AERONAUTICAL CHARTING MEETING
Instrument Procedures Group
Meeting 22-01 – April 25-26, 2022

RECOMMENDATION DOCUMENT

FAA Control # 22-01-368

Subject: MSA Center for Non-RNAV Procedures

Figure 5: KCBE L23 MSA vs R23 TAA

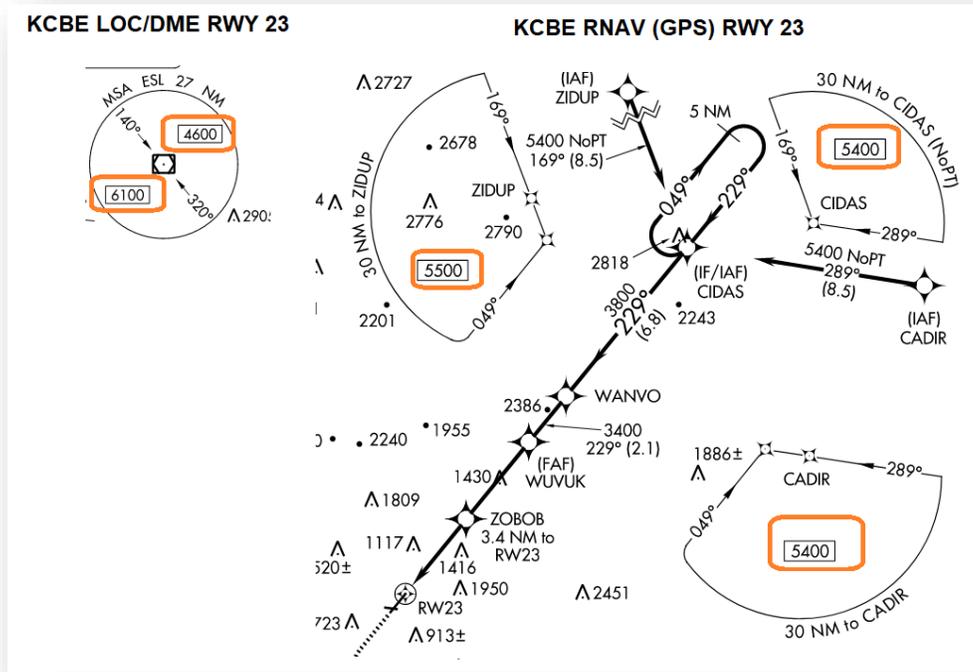
This is highlighted when you compare the LOC/DME RWY 23's MSA values versus the RNAV (GPS) RWY 23's TAA values.

So, how would the pilot know the safe IFR off-route altitudes to get to the KCBE LOC/DME RWY 23 procedure not covered by the MSA? They would have to look at the IFR Enroute L-23 chart:

Figure 7: KCBE LOC/DME RWY 23

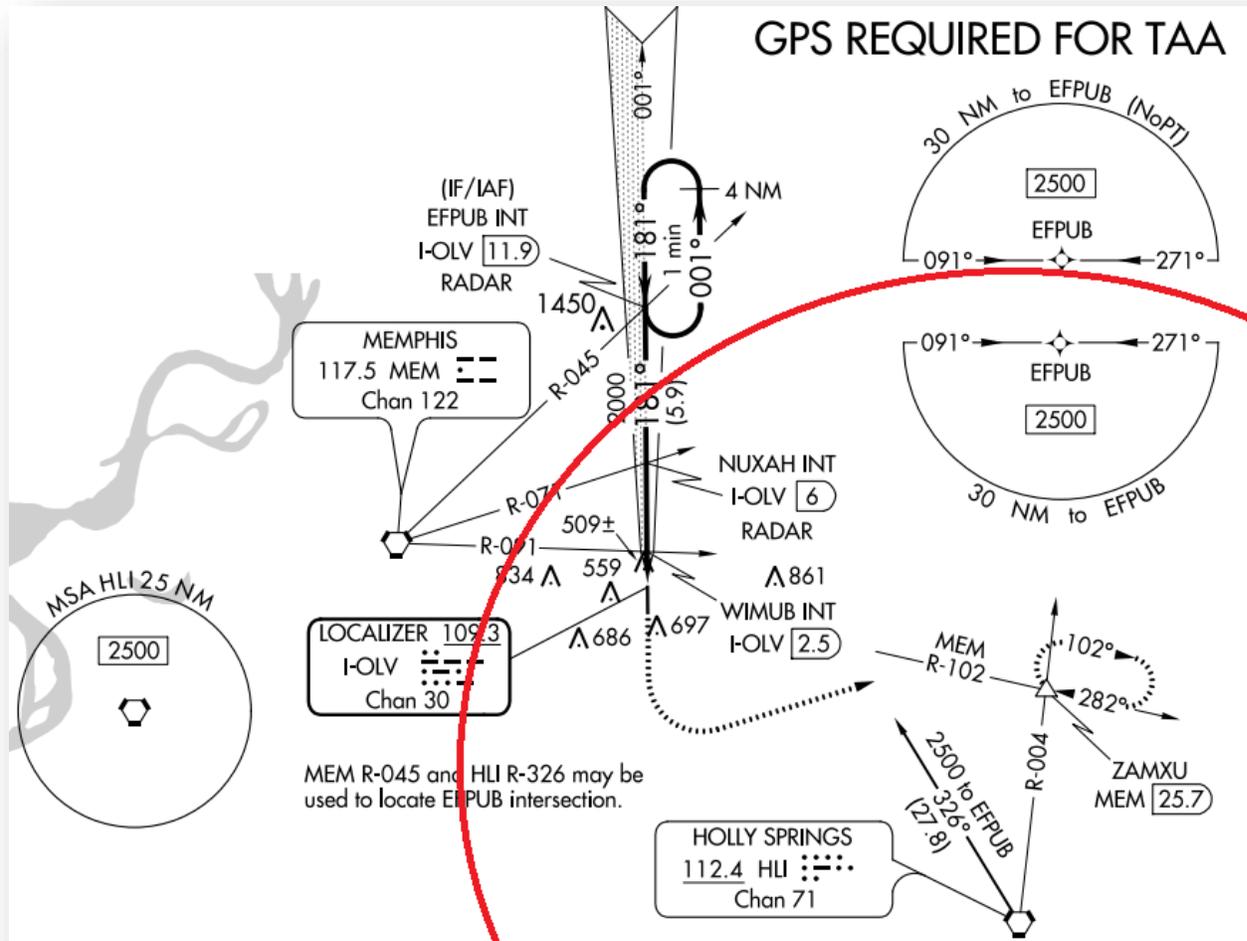
The KOLV ILS or LOC RWY 18 has a MSA and a TAA! The approach's MSA is centered on the HLI VORTAC which is 19 NM to the southeast of the KOLV airport and the TAA is centered on the EFPUB INT. The 25 NM radius of the MSA, shown in the image as a red circle, protects the arrivals from the southeast. The TAA would be needed for the rest of the arrivals but according to the plan-view note would require GPS equipment: "GPS REQUIRED FOR TAA".
